Re: Linden Road Landfill Site  
Flint Township, Michigan

1. Revised Work Plan for the installation of new shallow monitoring wells inside the new site boundary.
2. Revised Section 2.1.1 of the Operation and Maintenance Plan.

### WORK PLAN FOR THE INSTALLATION OF NEW SHALLOW MONITORING WELLS INSIDE THE NEW SITE BOUNDARY

#### LINDEN ROAD SITE, FLINT TOWNSHIP, MICHIGAN

FIGURE A-1

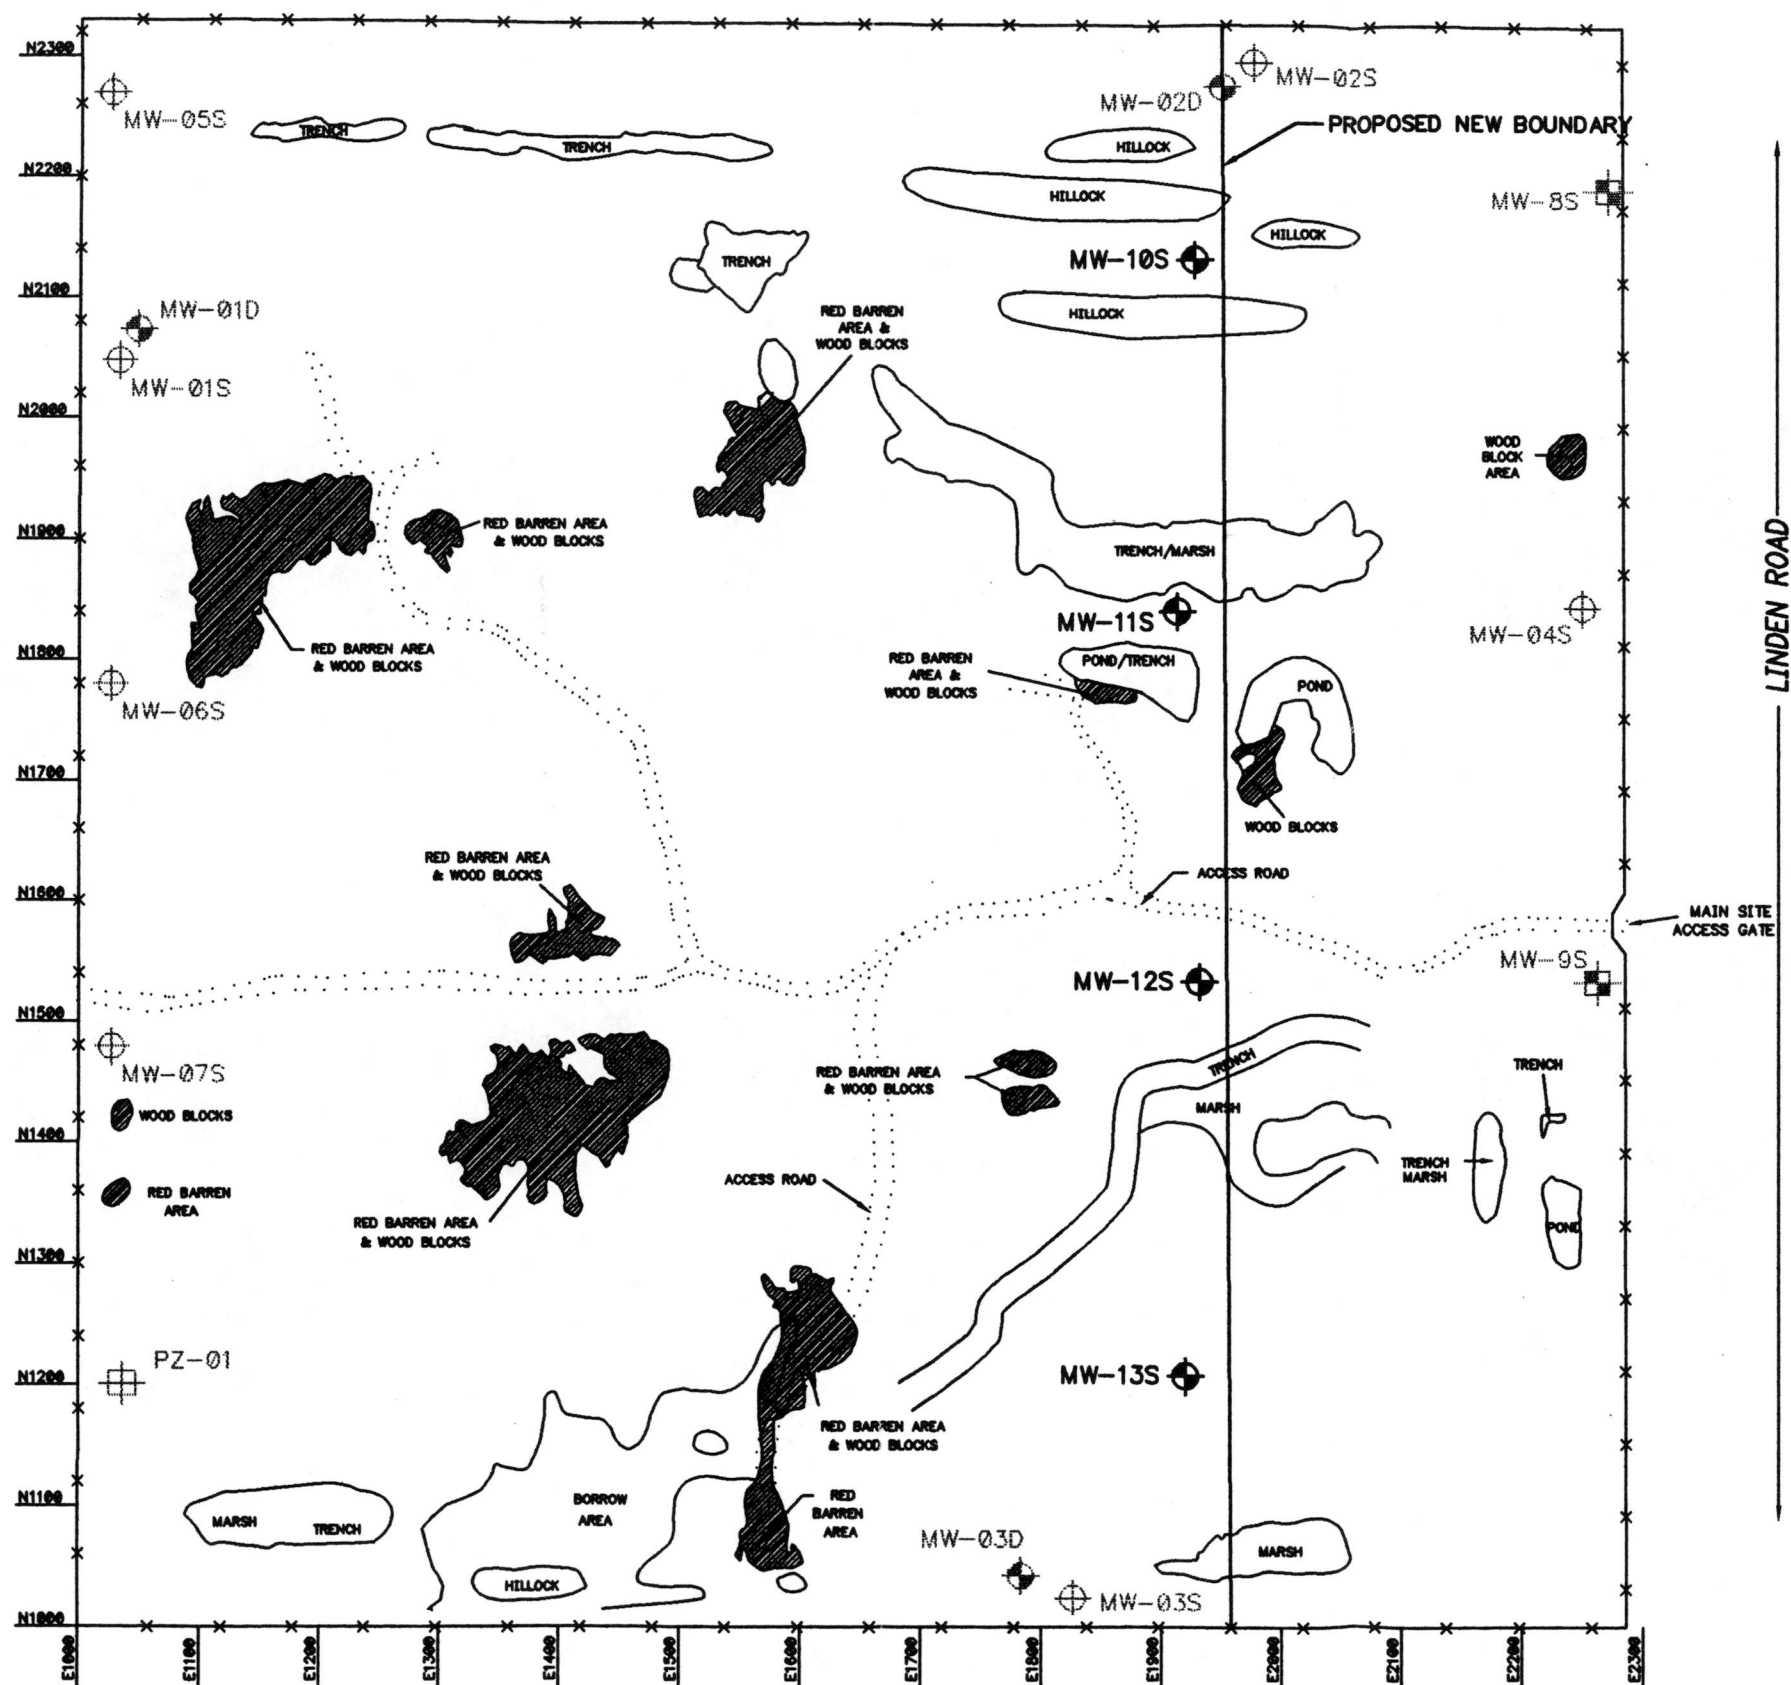
Four new downgradient shallow monitoring wells (MW-10S, MW-11S, MW-12S, and MW-13S) will be installed along the inside of the new eastern boundary of the site. The attached Figure A-1 shows the locations of both the existing monitoring wells and the proposed new wells. The monitoring wells will be installed as close as possible to the new property boundary (Figure A-1).
